Access Compliance Report

Public Rights-of-Way

(Pedestrian Signals)

Intersection ID: N/A	Main Street:	Cross Street: N/A	Location: N/A
ADA ID: 33F337F25143	Signal Type: One Push Button-Non APS	Overall Compliance: No	Severity Score: BTN 1: N/A BTN 2: N/A No BTN: N/A
Codes/Mitigation Info/Possible Solution		Field Measurements/Component Compliance

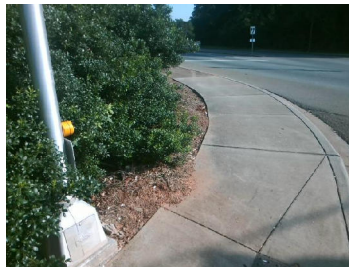
Surveyor Notes: TEXT HT 1/2

PROW/ADA: R410.6, R404.2, R406.2

Possible Solutions: Remove & Replace Sign.
Remove and Replace Clear Space.
